Fortis Garments Ltd

Holding No-100/1, Block B, Saheed Mosarrah Hossain Road, Purbo Chandora, Sofipur, Kaliakoir,
Gazipur
(24.035968 N, 90.270959 E)

15th April 2014

Observations

Ground floor plan

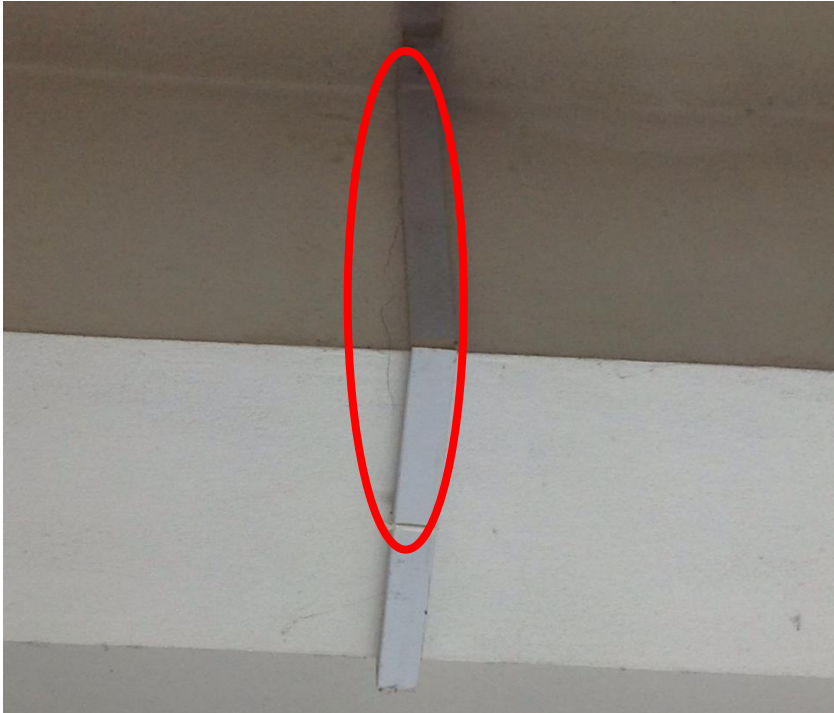
Outline calculations indicate the circled columns below are highly stressed under their current loading condition.

Cracking in beam

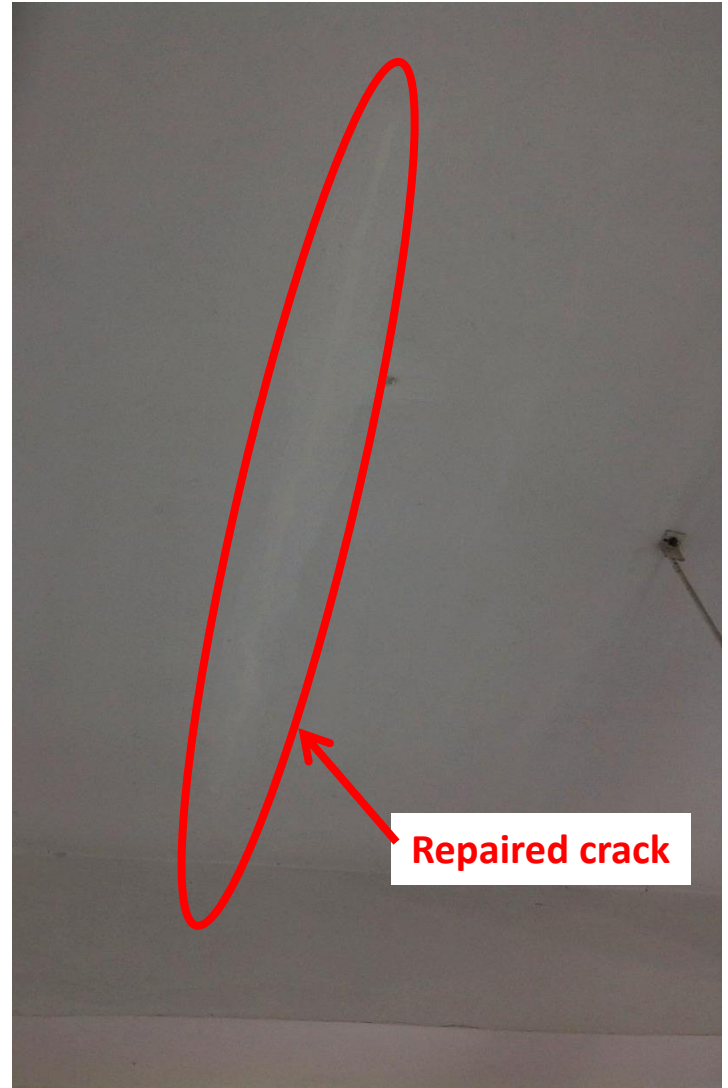
Cracking was observed in beams and/or floor slabs at some levels.

Undocumented cantilever

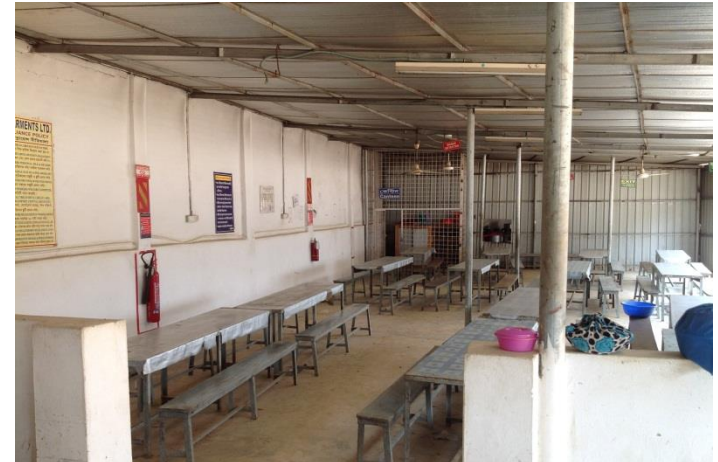
Several observations in the main factory building did not coordinate with the information presented in the structural drawings.

- Cantilever slabs
- Column locations
